**Deadline 7 Submissions**  
**Preston Farms Ltd ("PFL") and TCS Biosciences Ltd ("TCS")**

## Rosefield DCO Application examination

### Deadline 7 (final deadline) submissions/evidence of Preston Farms Limited (PFL) and TCS Biosciences Limited (TCS)

# Rosefield Solar Farm

Version 1 - E23 No Solar with no access

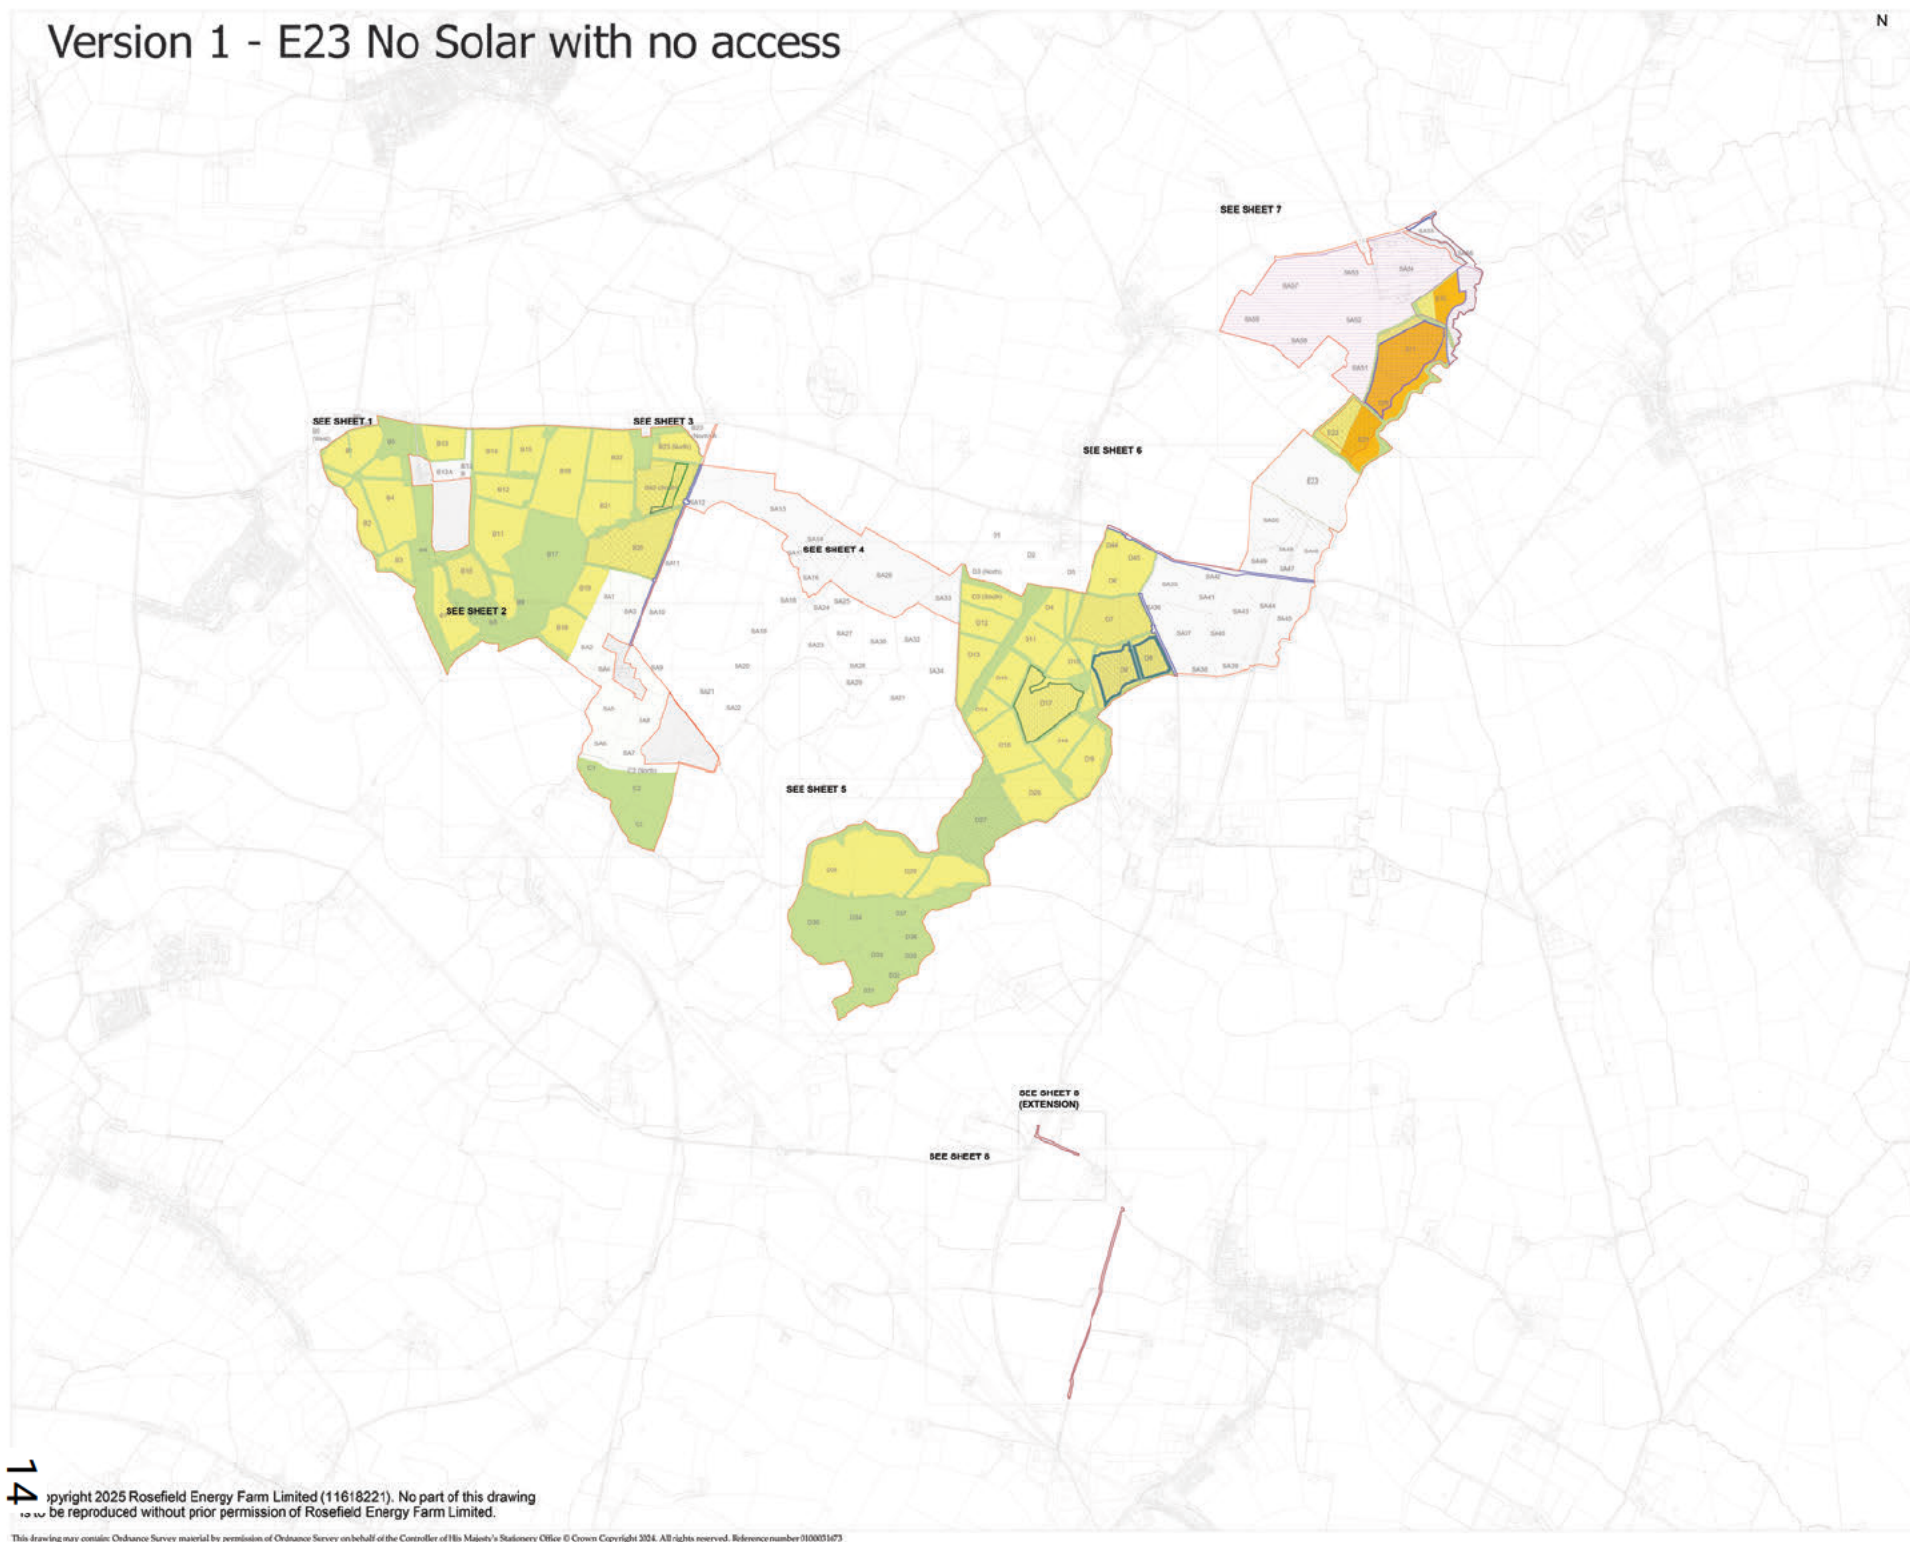
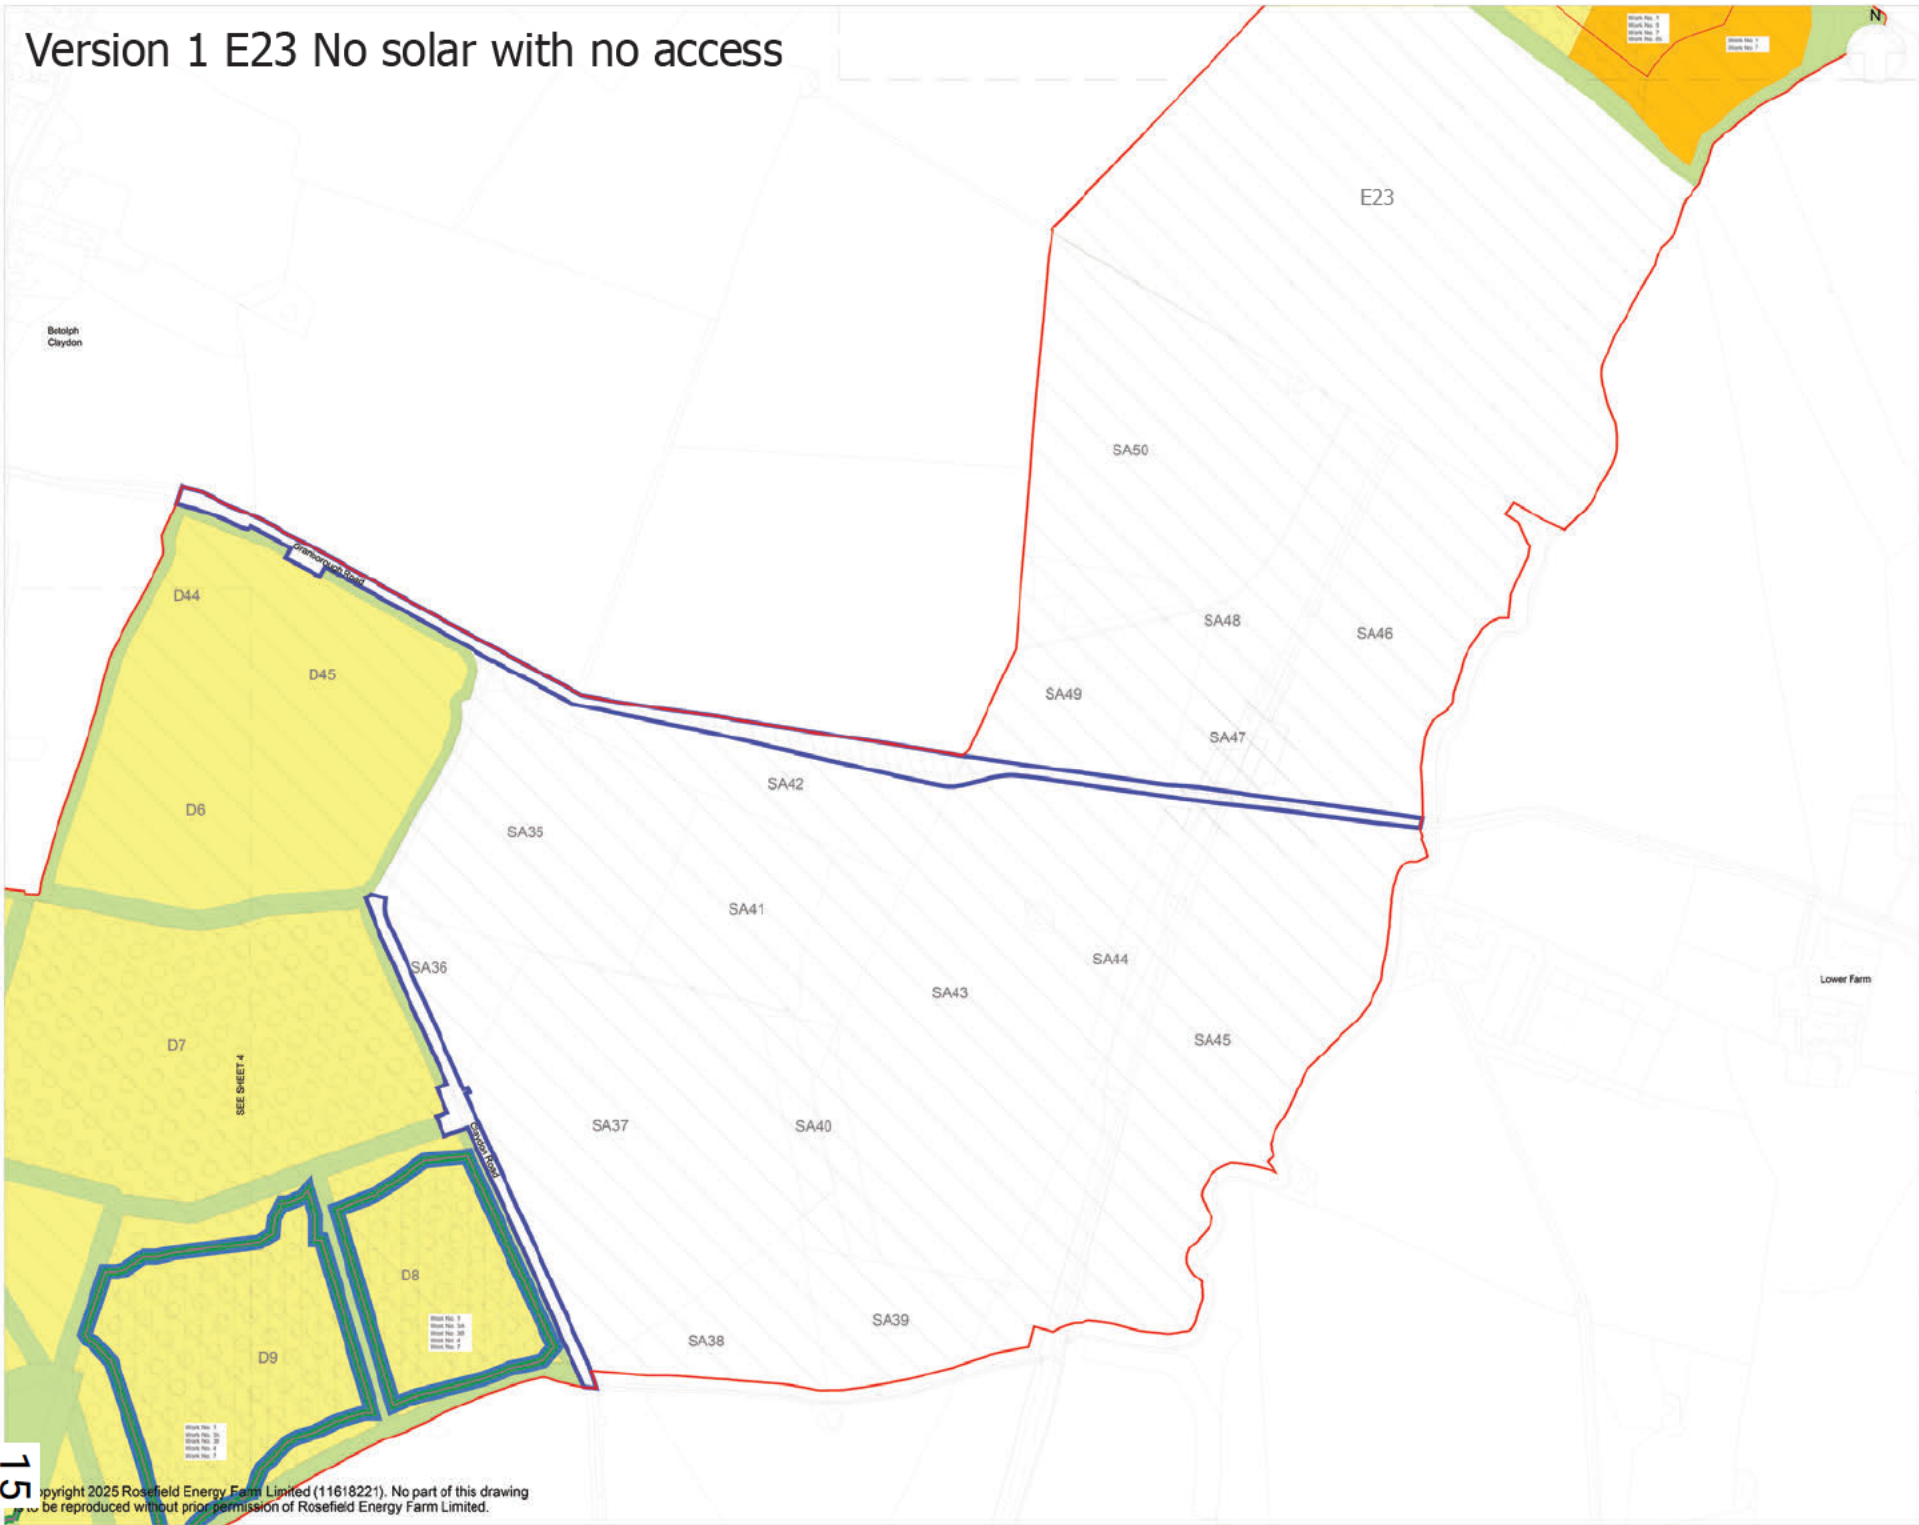
- Remove all need for above ground infrastructure on field E23 (Plot 6/13) (i.e. the solar PV presently proposed), by modifying the DCO accordingly. This would be by adjusting the Works plans accordingly, to remove solar PV from Plot 6/13 (see Sheet 6), and also making Plot 6/13 a plot within DCO Schedule 9, only for cable rights (or cable rights and access rights, subject to the issue below). Adjusted Works plans are attached (labelled "Version 1") and an adjusted dDCO Schedule 9 is also attached. See also further below. Note, the Development Description Figures **REP6-050** would also require corresponding adjustment (as would other documents). The Applicant has repeatedly confirmed (by its silence) that it agrees with PFL/TCS that such a modification would be non-material.

36. Necessary modifications to the Works plans and to the draft DCO are attached. The modifications to the Works plans show, first, PFL/TCS' primary position, with no access off the Granborough Road (labelled "Version 1)", and, second, PFL/TCS' secondary position, with access off the Granborough Road but moved to the east (still with ample separation from the brook) (labelled "Version 2").
